SERVICE BULLETIN

OUTBOARD MOTOR #61

REVISED DECEMBER 2007

BF75D • BF90D UNSTABLE ENGINE RPM

ECM PART
NUMBER LABEL

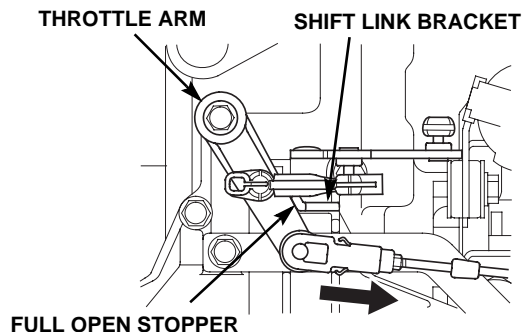
The ECM air/fuel programming may cause the engine to surge at various engine speeds. A new ECM is available that has revised programming to stabilize the engine speed through the entire rpm range.

The new ECM will have the new part number label on it (see Parts Information).

Description	Qty.	Part Number	Honda Code
ECM (BF75D)	1	34750-ZY9-013	8813438
ECM (BF90D)	1	34750-ZZ0-023	8813446

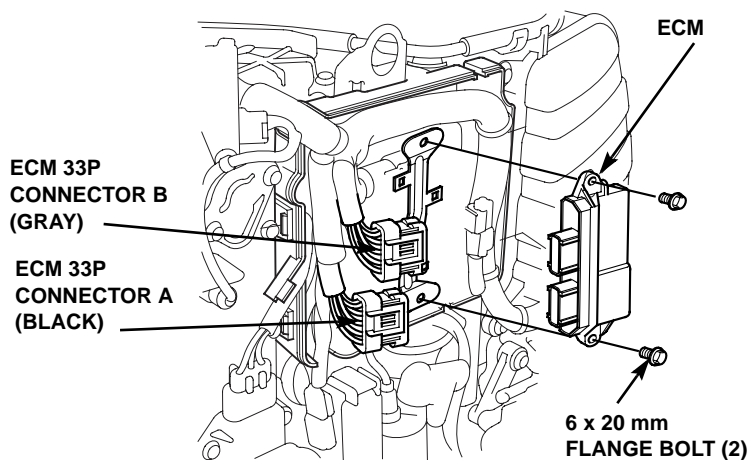
3. Disconnect the 33P connector B (gray) and the 33P connector A (black) from the ECM.
4. Remove the two 6 x 20 mm flange bolts and the ECM.
5. Install a new ECM in the reverse order of its removal.
6. Install the electric part cover.
7. Install the engine cover.
